PCN# 20251031003.1A

**Qualification of MIHO using qualified Process Technology, additional Assembly site
and BOM options for select devices
Change Notification / Sample Request**

The rev A is being issued to correct the additional site wafer diameter and CSO code.

Sample product shipping label (not actual product label):

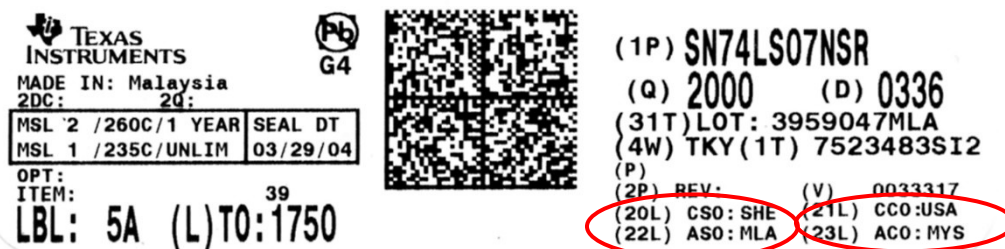
Current Fab Site			Additional Fab Site		
Current Fab Site	Process	Wafer Diameter	Additional Fab Site	Process	Wafer Diameter
CFAB	VDIODE	200 mm	MIHO	VDIODE	200 mm
Construction differences are as follows:					
	Current		Additional		
Assembly Site	TIPI		CDAT		
Lead Finish	NiPdAu		Post plate-AG Spot		
Mount compound	4226215		4229877		
Qual details are provided in the Qual Data Section.					
Reason for Change:					
Adding a 2 nd source facility for supply continuity.					
Anticipated impact on Form, Fit, Function, Quality or Reliability (positive / negative):					
None					
Impact on Environmental Ratings:					
Checked boxes indicate the status of environmental ratings following implementation of this change. If below boxes are checked, there are no changes to the associated environmental ratings.					
RoHS		REACH		Green Status	
☒ No Change		☒ No Change		☒ No Change	
Changes to product identification resulting from this PCN:
